Subject: DIR1701 and DIR1703 UNLOCK problem

### Summary of Problem and Proposed Solution

Fig. 1 LRCKO duty cycle and preamble position change at CKTRNS = HIGH

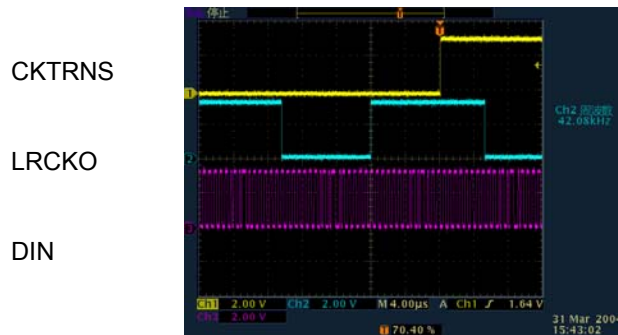
When the sampling frequency changes, the DIR1701/DIR1703 unlock and fail to re-lock at the new sampling rate. In general, during normal operation an S/PDIF receiver outputs an UNLOCK flag when the sampling frequency of the S/PDIF data changes. After the receiver has locked to the new sampling frequency, the device outputs a LOCK flag. The DIR1701/DIR1703 is unable to correctly re-lock onto the new sampling frequency. Specifically, after the sampling frequency changes the LRCKO output becomes unstable and can create noise that will be passed through an audio DSP or audio DAC.

To lock onto a new sampling frequency, the DIR1701/DIR1703 requires an external reset signal every time the S/PDIF audio sampling frequency changes. A microcontroller or DSP would typically be required to provide this reset signal in a system.
